Maine Natural Areas Program

Date: February 24, 2010

Re: Rare and exemplary botanical features, DP 4860, Trans Canada Wind Development Application, Chain of Ponds Twp, Kibby Twp. Maine.

**Sisk Mountain:
Fir - Heart-leaved Birch Subalpine
Forest Natural Community (358 ac)**

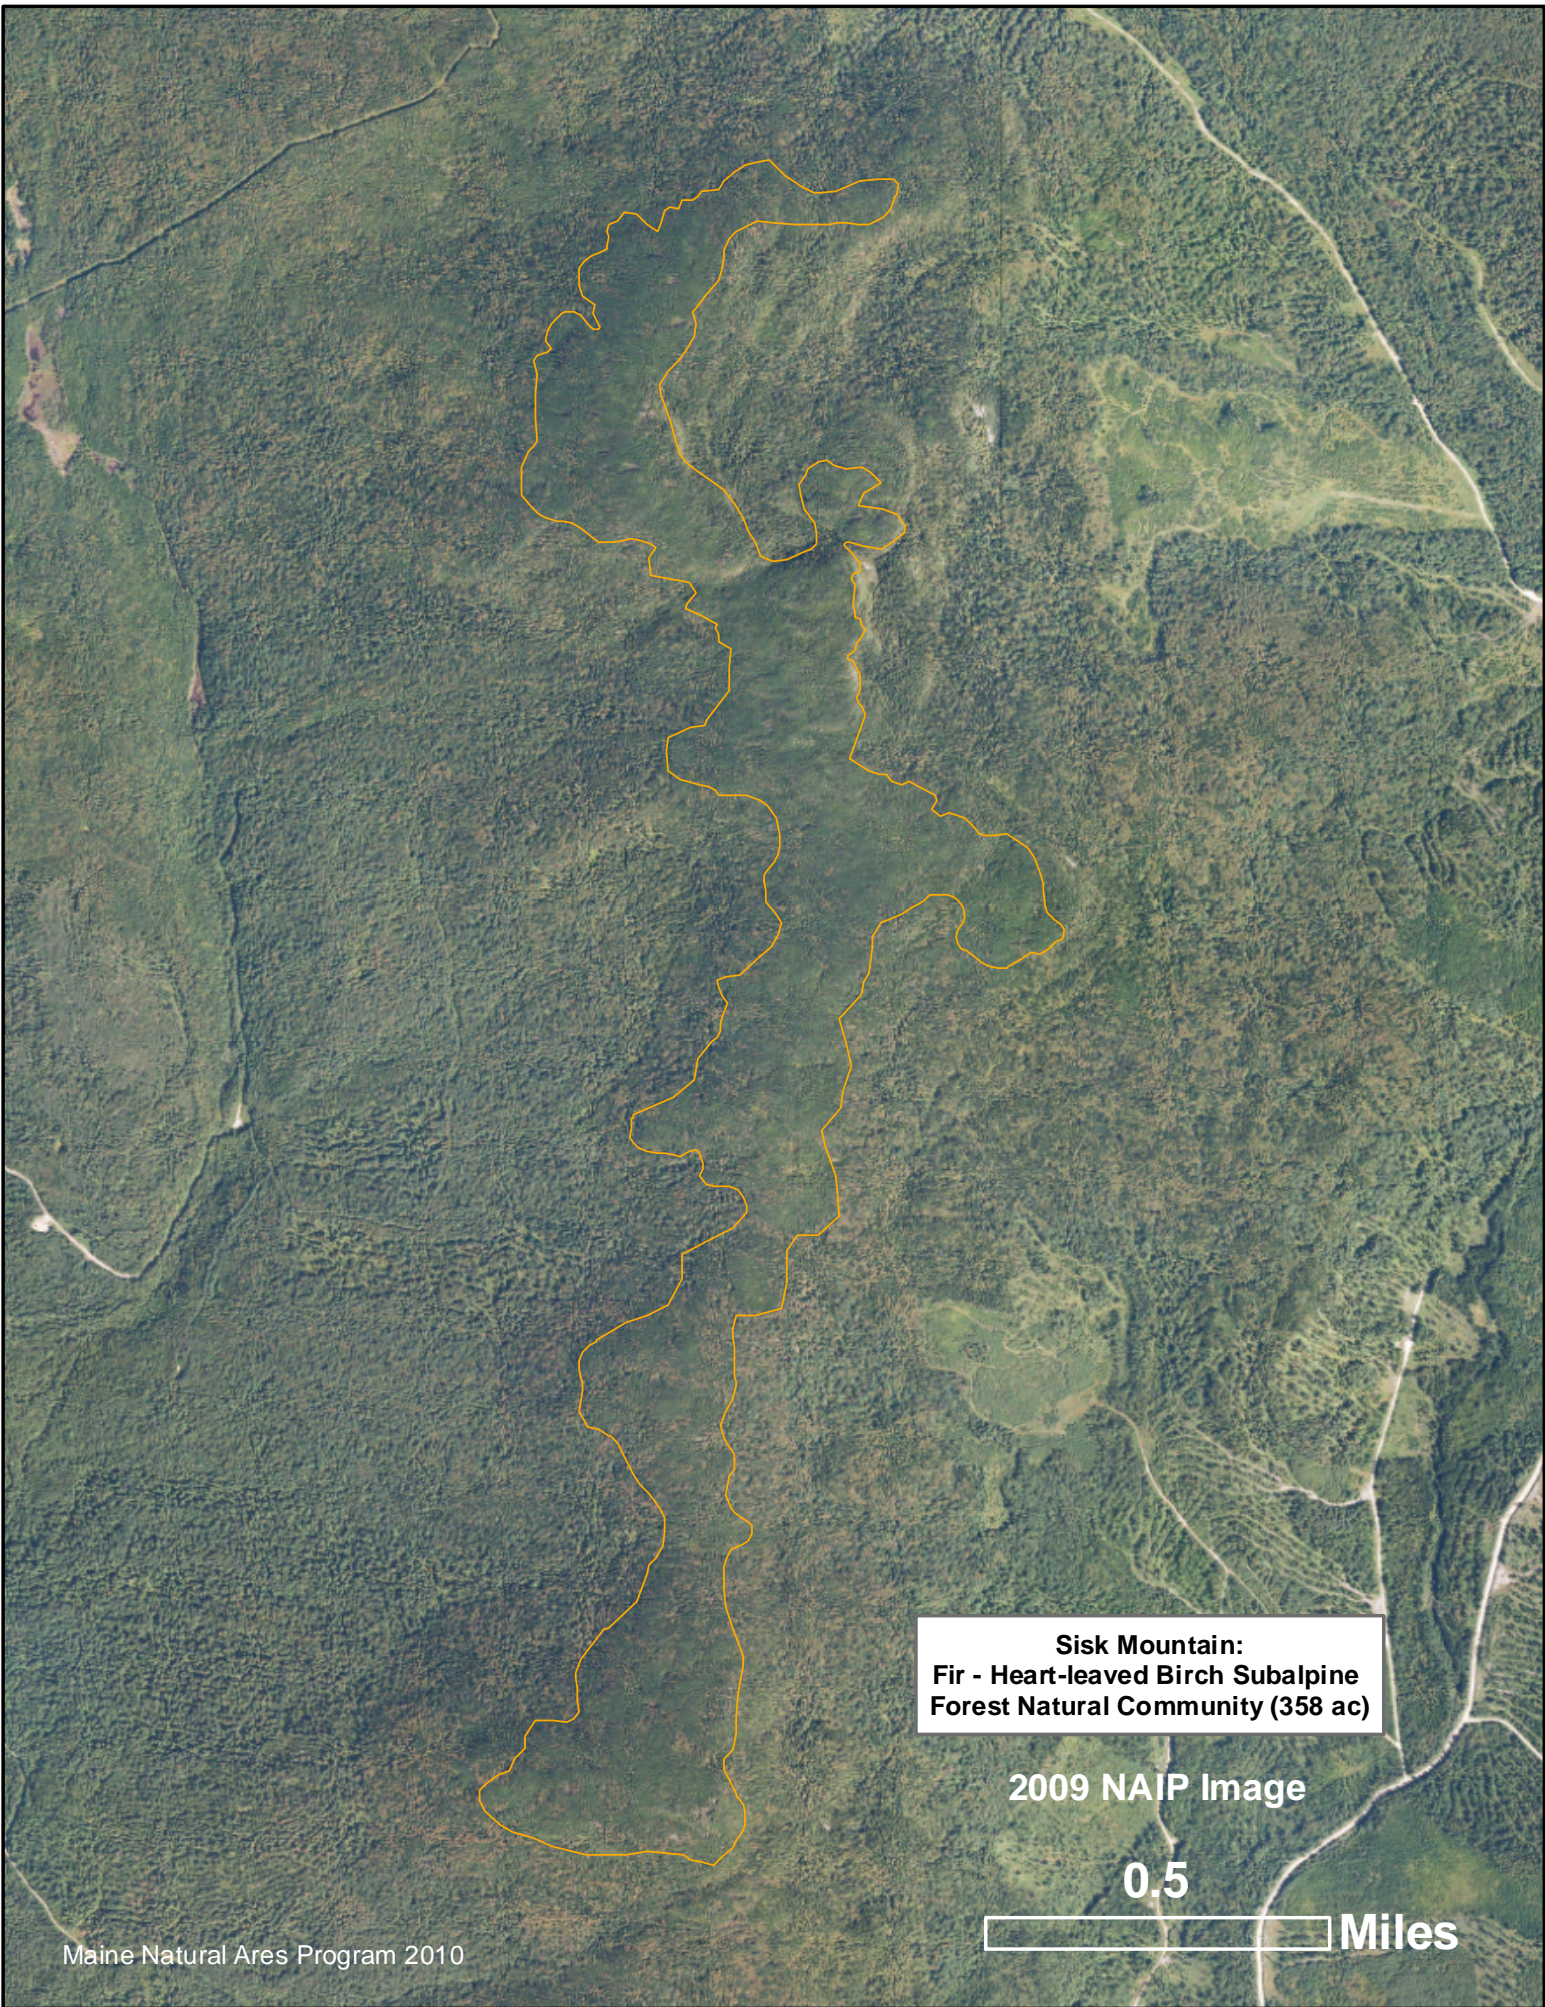
Based on the project shape provided by the applicant, it is estimated that 42 acres within the Fir – Heart-leaved Birch Sub-alpine Forest will be cleared. The clearing for the project will fragment portions of the northern half of the natural community effectively isolating some areas so that their natural value as Fir – Heart-leaved Birch Sub-alpine Forest will be lost. Clearing will also create unnatural edges within the natural community that will alter the habitat immediately adjacent. Expected impacts to the edge of the natural community include increased light and wind, and will likely change the habitat by removing moisture and damaging trees. To account for the impacts along

the edges that will be created within the natural community, MNAP added a 50' buffer to the proposed clearing. In sum, MNAP estimates that the total impact to the Fir – Heart-leaved Birch Sub-alpine Forest from site clearing, impacts caused by creating edges, and from fragmentation will be approximately 80 acres.

Due to the rarity of this forest type, the Maine Natural Areas Program recommends that every effort be made to minimize impacts to this system. Therefore, we respectfully request that the LURC Commissioners include in their consideration the removal of Turbine 11.

As currently designed, Turbine 11 effectively fragments the remaining core of the northern portion of the Fir – Heart-leaved Birch Sub-alpine Forest into two smaller areas. Removal of Turbine 11 would considerably decrease impacts to the Fir – Heart-leaved Birch Sub-alpine Forest and result in a northern core of approximately 62 contiguous acres. The removal of Turbine 11 reduces the impact from 80 to 75 acres but considerably reduces fragmentation of the remaining northern portion of the natural community.
